U.S. CONSUMER PRODUCT SAFETY COMMISSION
4330 EAST WEST HIGHWAY
BETHESDA, MD 20814

May 25, 2010

Point-by-Point response

List of all planned modifications to Public Playground Safety Handbook

60. Figure 21: Modify to show zone at end of slide, similar to the following:

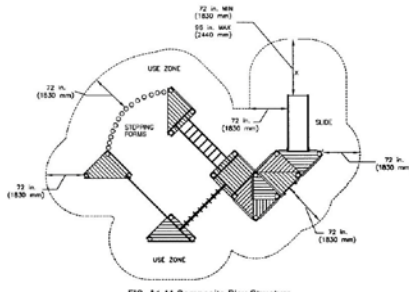
59. Figure 21: Caption to read "Use zone for *stand-alone* slides"

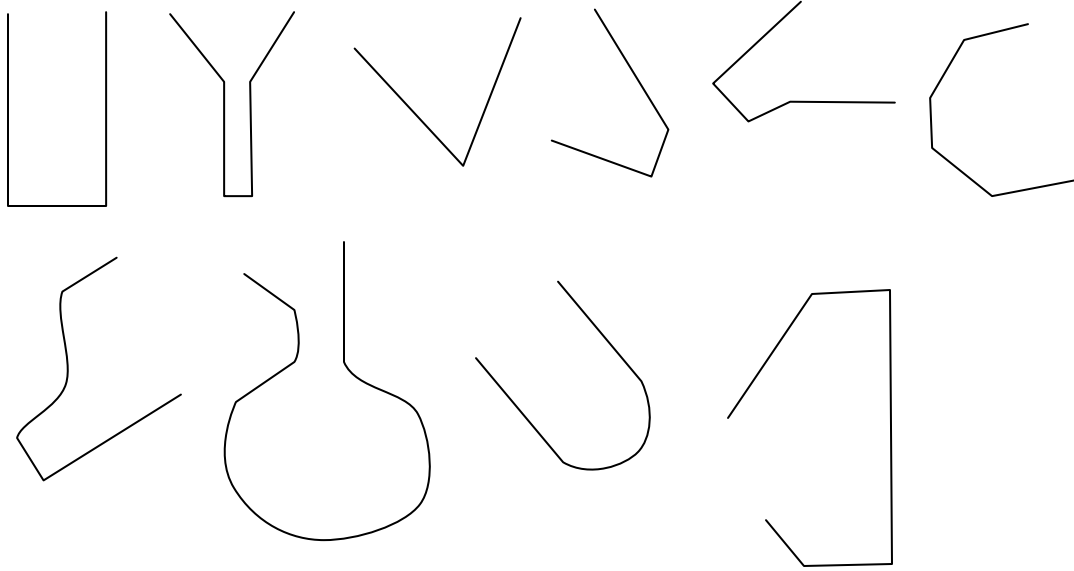
65. B.2.4 Angles: Delete section in its entirety, as it has been replaced by new section on Partially Bound Openings.
66. B.2.6.5 Flexible openings, Step 5: Modified to read “Determine *if* the probe can be pushed or pulled *completely* through the opening by a force no greater than 30 pounds on toddler playgrounds or 50 pounds on preschool-age and school-age playgrounds.”
67. B.2.6.5 Flexible openings, Step 5: Add representative Pass and Continue pictures provided.
68. B.2.6.5 Flexible openings, Step 7: Modified to read “Determine if the large head probe can be pushed or pulled *completely* through the opening by a force no greater than 30 pounds on toddler playgrounds or 50 pounds on preschool-age and school-age playgrounds.”
69. B.2.6.5 Flexible openings, Step 7: Add representative Pass and Fail pictures provided.
70. Appendix B: Add new section B.2.6.6 Partially Bound Openings.

A partially bound opening is any opening which has at least one side or portion open, such as a U- or V-shaped opening. These openings can still pose an entrapment hazard by allowing the neck to enter but not allowing the head to slip out. Several examples of this situation are shown in the figure below.

Note: Test procedure write-up is still in development and usability testing. Above graphics to be improved by graphic artist.
